Flight Procedures Cover Page	Task Action: P-NOTAM	Task Type: IAP	Estimated Chart Date: 05/14/2026	APWS Task ID: DDEC9EC38E9D45A09123DC891A6809C4	APWS Project ID: 98D8A809A7FB424683AB30FD9227A792
Procedure: RNAV (GPS) RWY 4 ORIG-C		Enroute: NO	Specialist: Johnson, Timothy		Agreement Number:
Airport ID: OM4			Airport City: CAMDEN		State: TN
Facility ID:	Facility Type:	Flight Inspection Remark Type:

RNAV (GPS) RWY 4
BENTON COUNTY (ØM4)

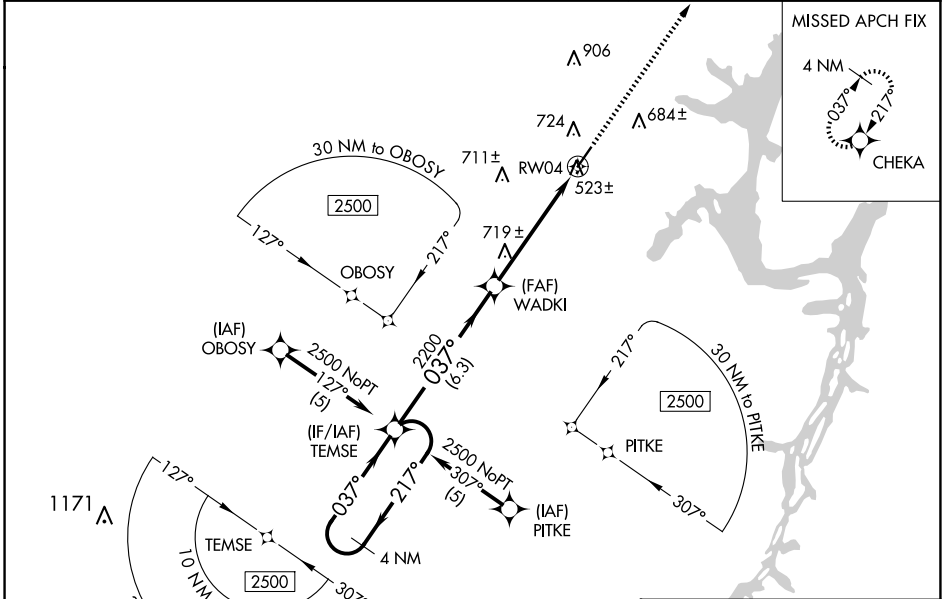
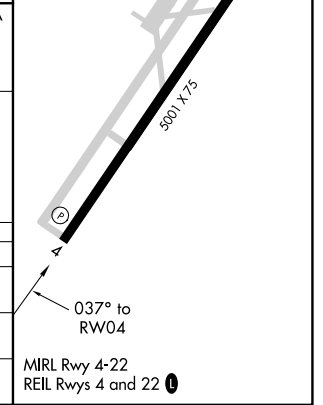
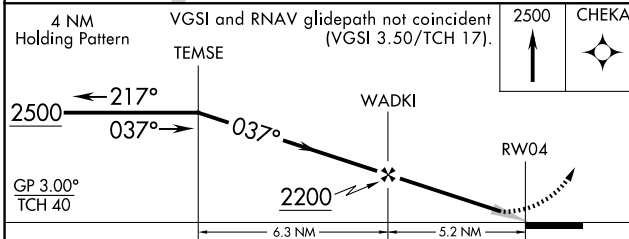
Visibility Initiative (Garmin) - Update IAP visibility minimums IAW Order 8260.3, Chapter 3, Section 3-3. Visibility Minimums.
